Planning Commission Issues Report

Subject: Change of Zoning Issues Report

Petition: **P.Z. 02-2015 Falling Leaves Estates II (1925 & 1921 Wilson Ave)**

RE: P.Z. 02-2015 Falling Leaves Estates II (1925 & 1921 Wilson Avenue)

Typical 100' Section of
Landscaped Buffer

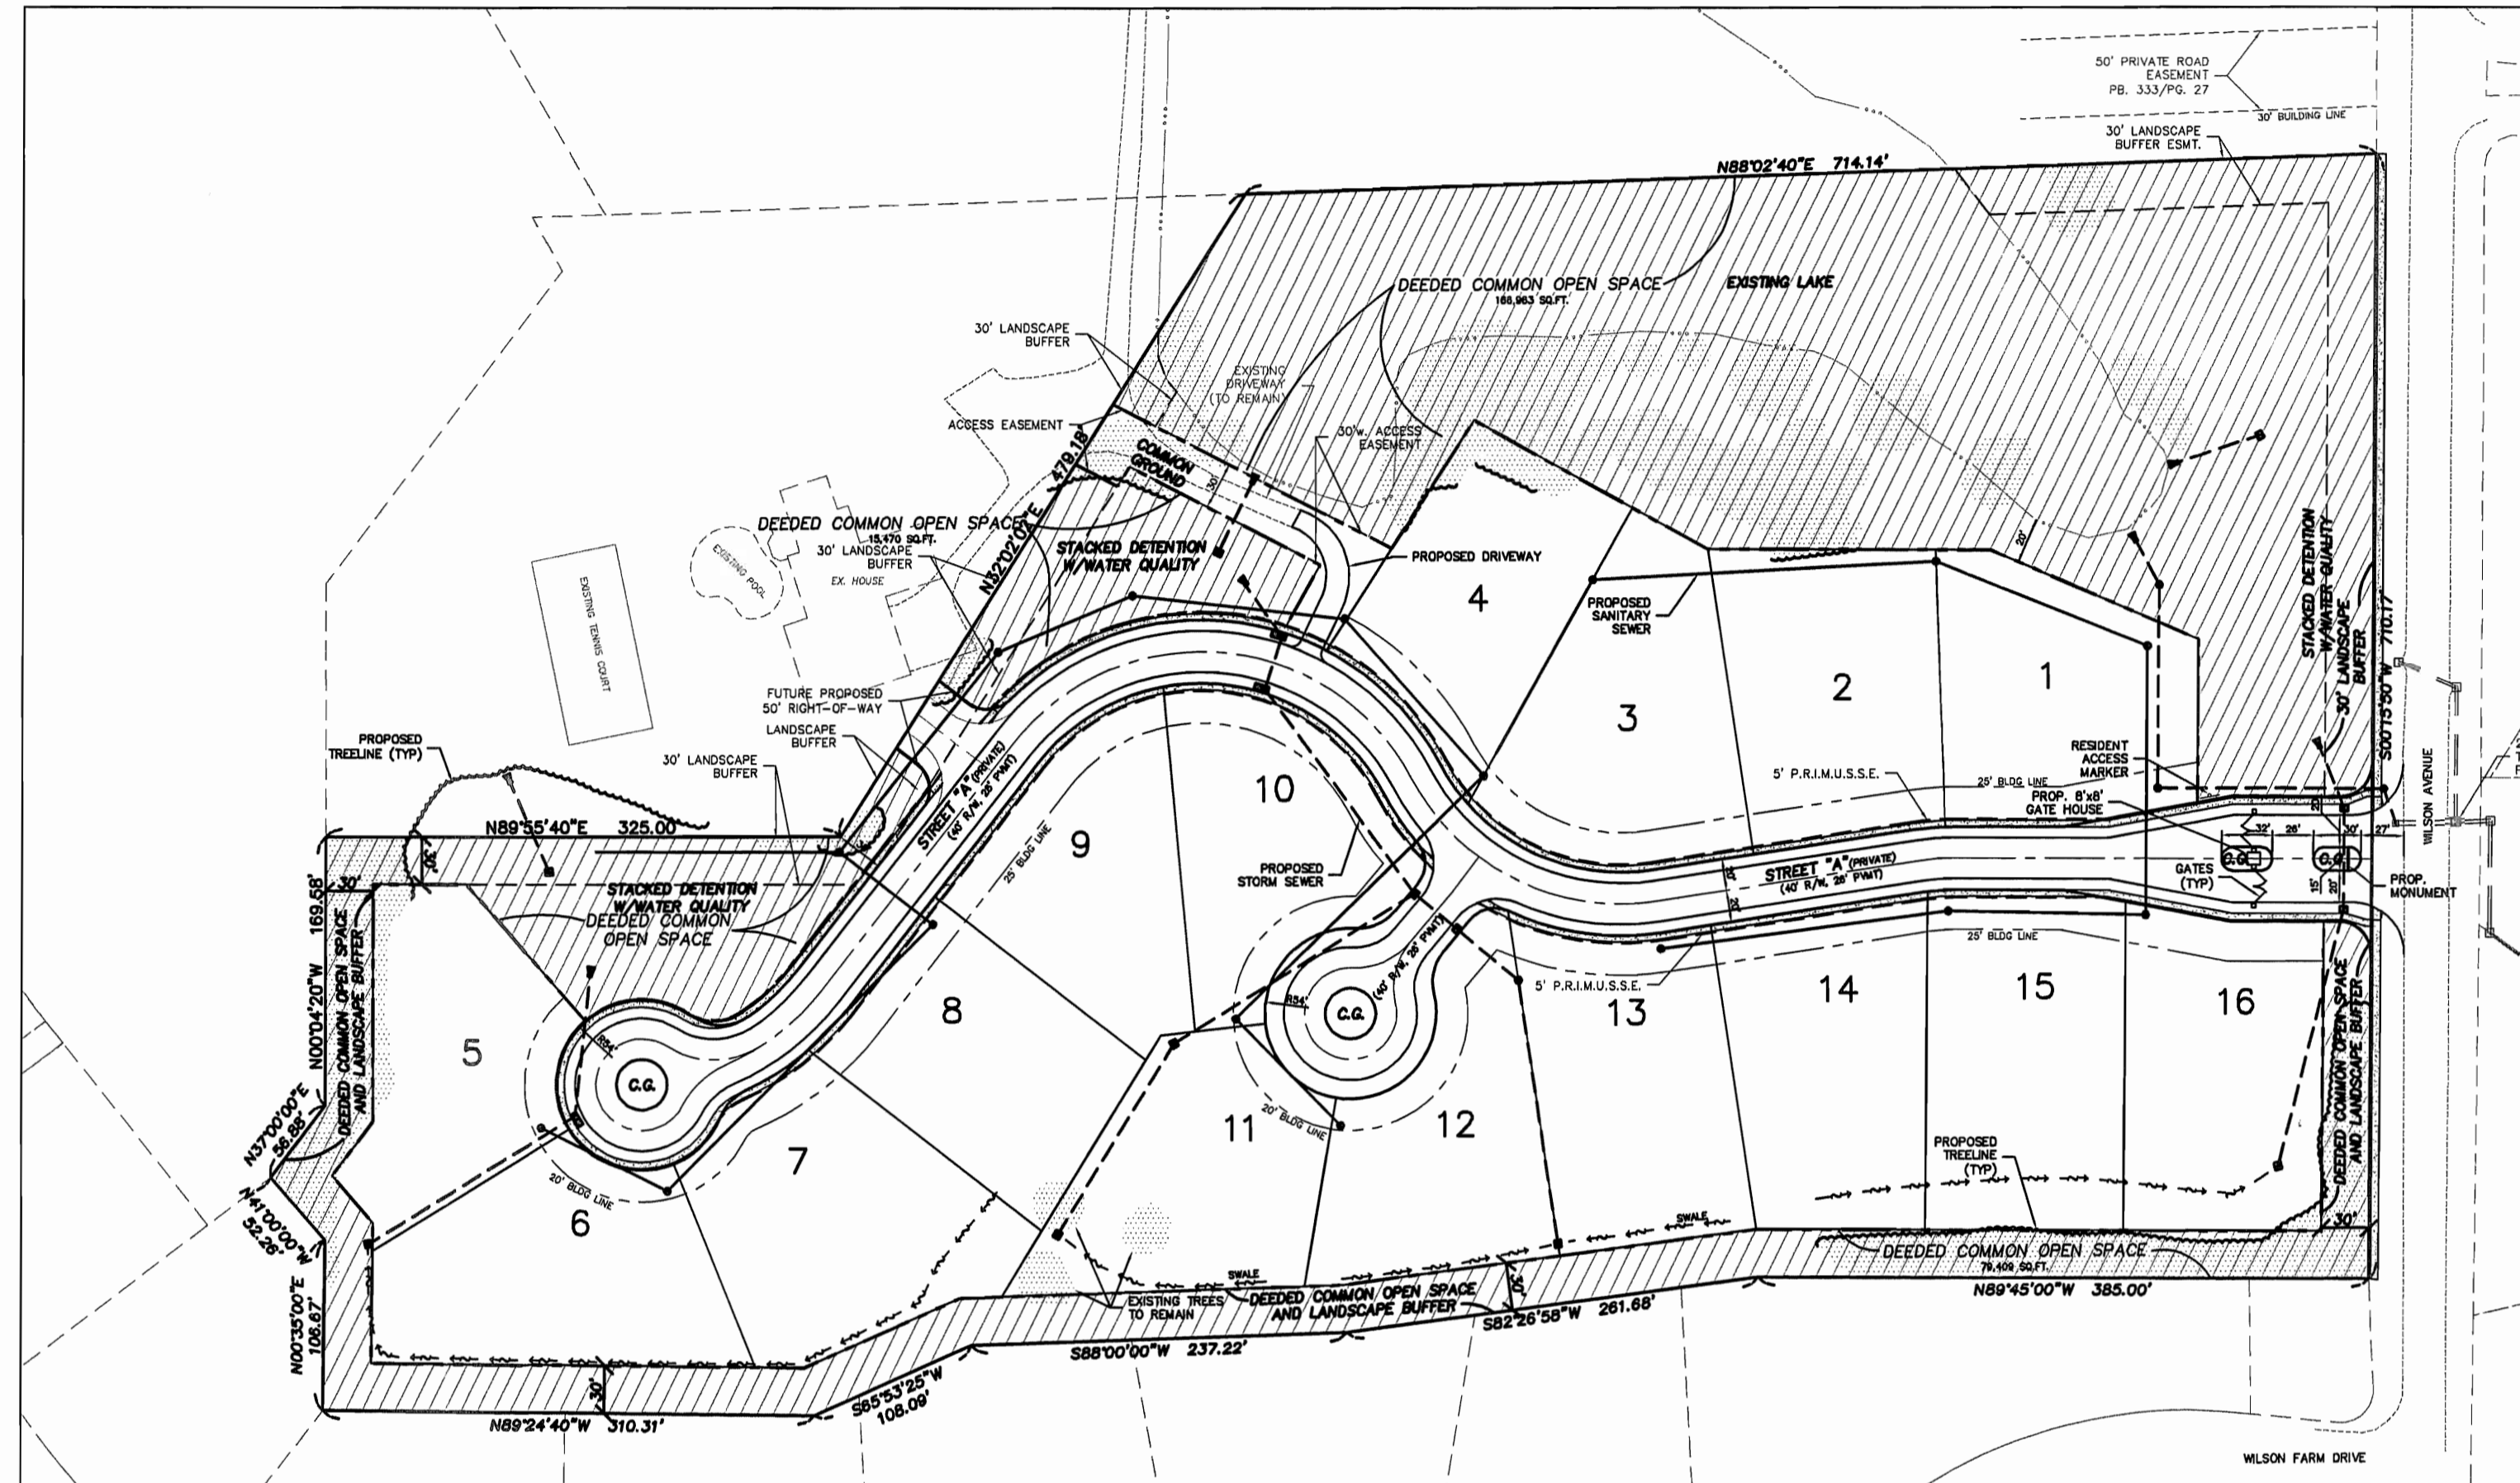
9. Concern was expressed at the meeting as to the future plans for the perimeter buffer areas. Please confirm these areas will include a mix of plantings.

The perimeter buffer areas will be landscaped, and the Buffer area along the Southern boundary in particular will be extensively landscaped. See Landscape Buffer Typical 100' section detail on Revised Plan submitted with these responses.

Falling Leaves Estates II
CHESTERFIELD, MISSOURI
Preliminary Development Plan
Cover Sheet

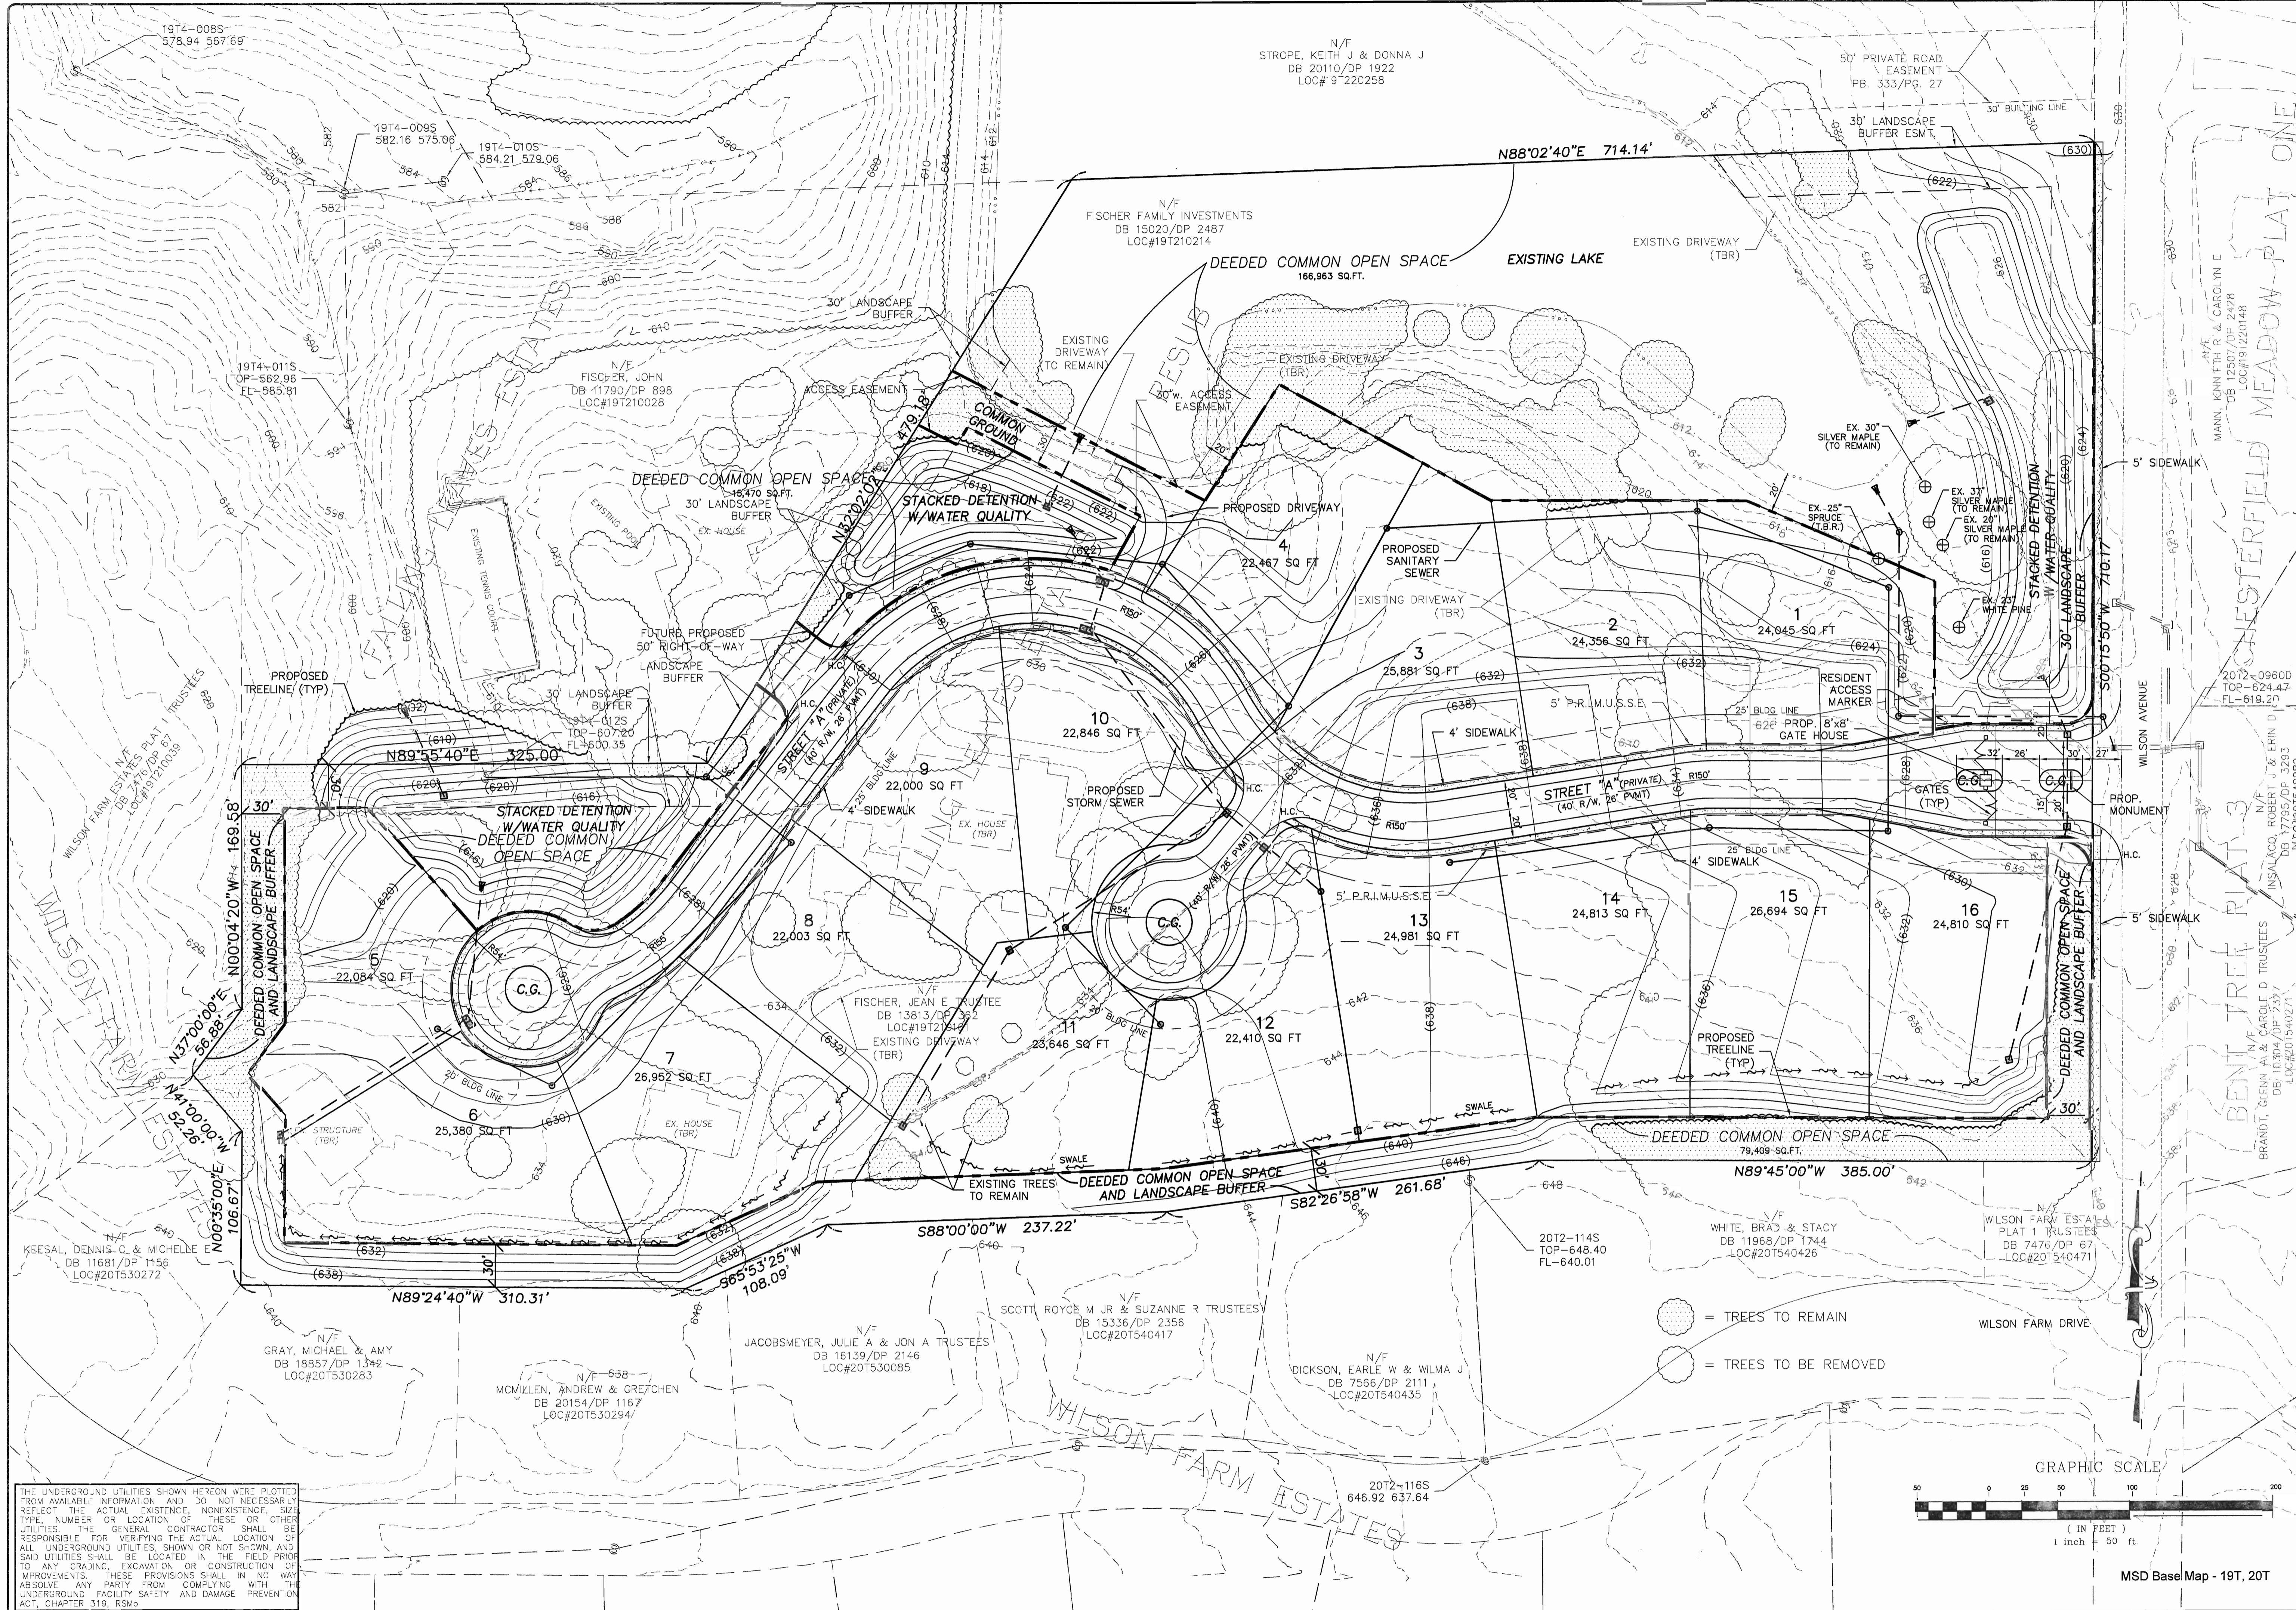
22. Site Information, Sheet 1.1: Review and revise the Flood Map Firm No. Records indicate these properties are on Firm 29189C0164K dated February 4, 2015.

See Revised Plan.
